SERVICE BULLETIN

M-1358

INDIA XL HORN BUTTON HARNESS PRODUCT PROGRAM 0915

Figure 2. Dual Lock™ Mount Locations

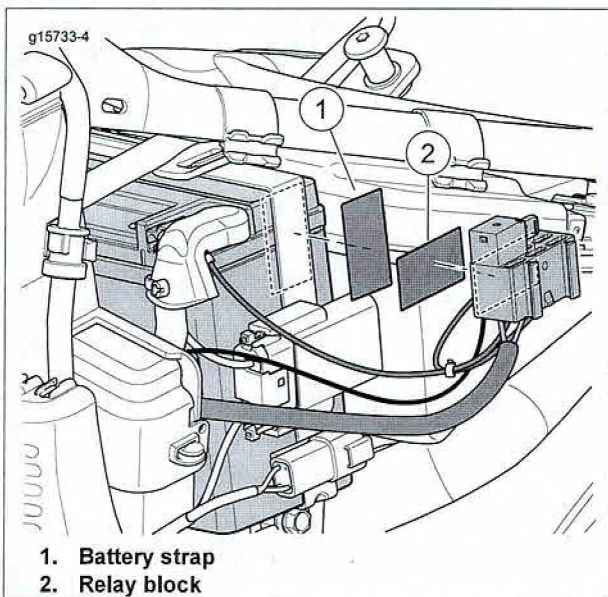
1. See Figure 2. Install the relay block with fuse.
 - a. Clean the battery strap with denatured alcohol.
 - b. Cut the Dual Lock™ mount in half.
 - c. Remove plastic film backing. Press to battery strap (1).
 - d. Remove plastic film backing. Press to back of relay connector block (2).
 - e. Mate the connector block to the battery strap.

Figure 3. Cable Strap Locations

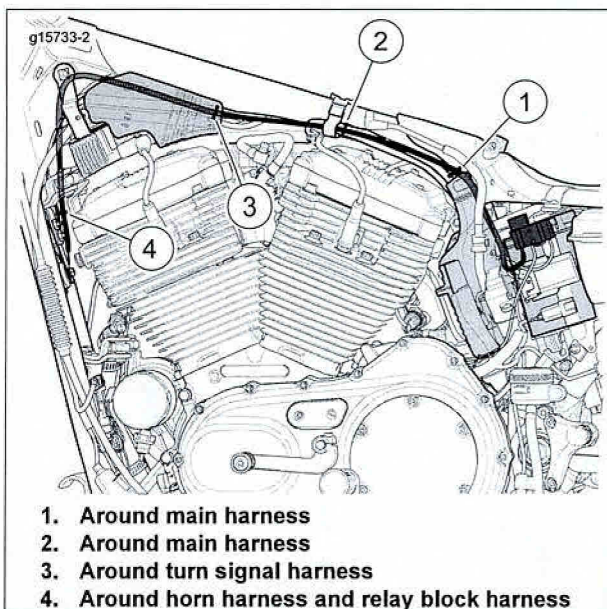
2. Route the relay harness.
 - a. Remove the electrical caddy screw to separate electrical caddy halves.
 - b. Route the wire harness under the positive cable guide on the back of the fuse block to the trough in the ECM caddy.
 - c. Route the wire harness up the trough.
 - d. Route the wire harness alongside the main harness and through the electrical caddy halves.
 - e. Inside the caddy, route the wire harness along the black conduit harness that follows the path of the horn harness.
 - f. See Figure 3. Loosely install the four cable straps.

Figure 5. Relay Harness Horn Connections

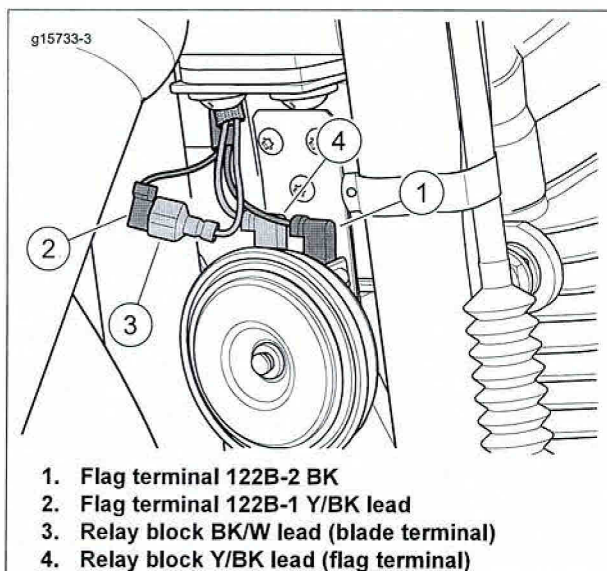
See Figure 5. The BK lead [122B-2] (1) from the main harness remains connected.

5. Connect the wire leads to the horn.
 - a. Remove the Y/BK lead from the horn.
 - b. Connect the Y/BK lead (2) to the BK/W lead (3) from the relay harness.
 - c. Connect the Y/BK lead (4) from the relay harness to (right side) horn terminal [122A-1].
6. Adjust the wire harness as necessary. Tighten the cable straps. Cut off the ends.
